1 Products affected

2 Type of change

Product Change Notification					PCN Global Labeling		
owner	creation date	release date	released by	change order no	rev	page	D10-058-189
huberth	02.06.2021	02.06.2021	muehlema	2022100	C	1 of 2

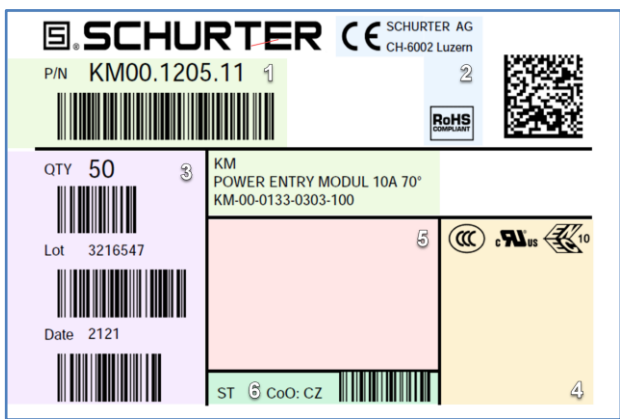
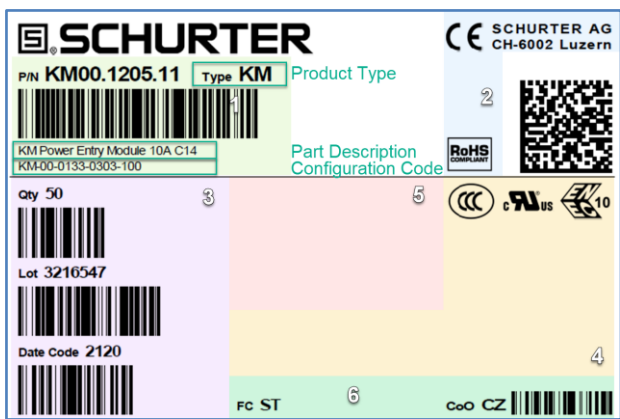
All product types listed in section 1 receive a new label layout.

To better visualize the changes, we have used colors and numbers to cluster information into the following sections (The colors and white numbers are not part of the new label layout):

Product identification section: To improve readability, we clustered all the information concerning product identification in this group. To increase clarity, we introduce our product configuration code into this area.	1
Product conformity section: Identical information was slightly rearranged.	2
Product logistics section: Label names changed. Information was slightly rearranged.	3
Product approval section: Identical information was slightly rearranged.	4
Interruption ratings section: Identical information was slightly rearranged.	5
Origin information section: Label for Factory Code was added. Information was slightly rearranged.	6
